ADDENDUM NO. 1

PROJECT: **Gillespie County Airport (T82)**
 Airport Pavement Rehabilitation, New Hangar Apron and Helicopter Parking
 Ramp, and Electrical Improvements
 TxDOT CSJ No. 1214FRBRG
 Klotz Project No. 0500.036.000

ISSUE DATE: February 2, 2012

PAVEMENT MARKING PLAN
(SHEET 1 OF 2)

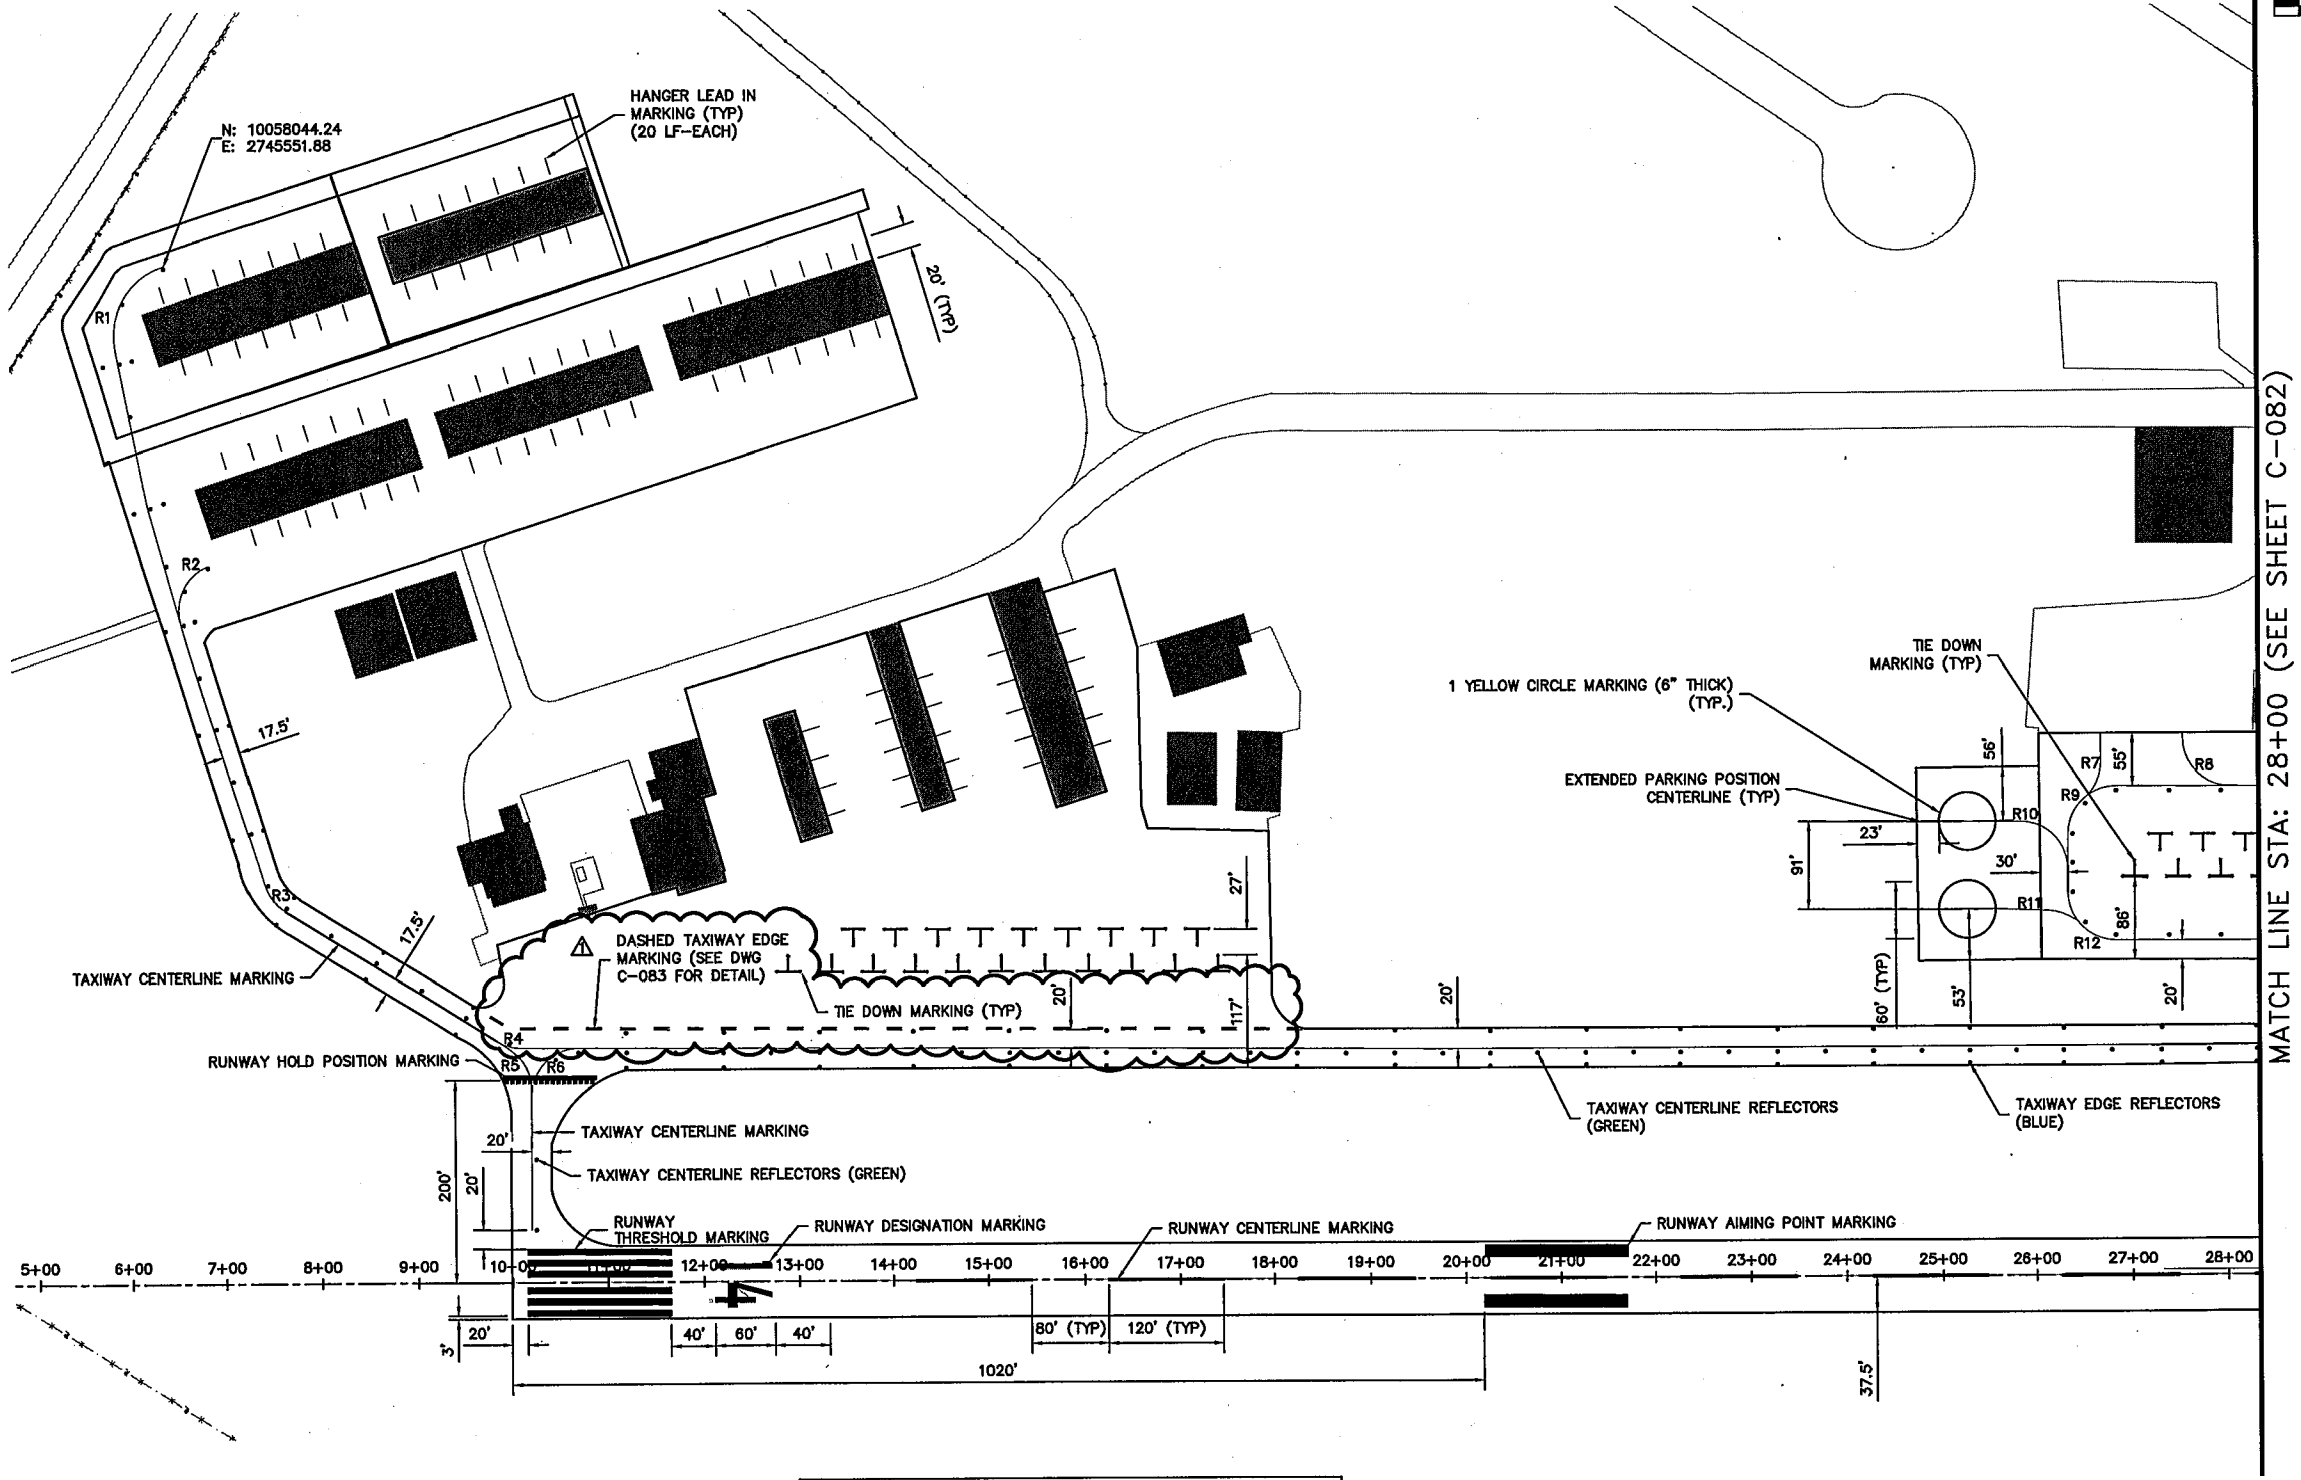
1. **REPLACE** Sheet 4 of 51, “General Notes” with the attached “General Notes” of Addendum No. 1.
2. **REPLACE** Sheet 12 of 51, “Construction Sequence Plan” with the attached “Construction Sequence Plan” of Addendum No. 1.
3. **REPLACE** Sheet 33 of 51, “Pavement Marking Plan (Sheet 1 of 2)” with the attached “Pavement Marking Plan (Sheet 1 of 2)” of Addendum No. 1.
4. **REPLACE** Sheet 34 of 51, “Pavement Marking Plan (Sheet 2 of 2)” with the attached “Pavement Marking Plan (Sheet 2 of 2)” of Addendum No. 1.
5. **REPLACE** Sheet 35 of 51, “Pavement Marking Details (Sheet 1 of 2)” with the attached
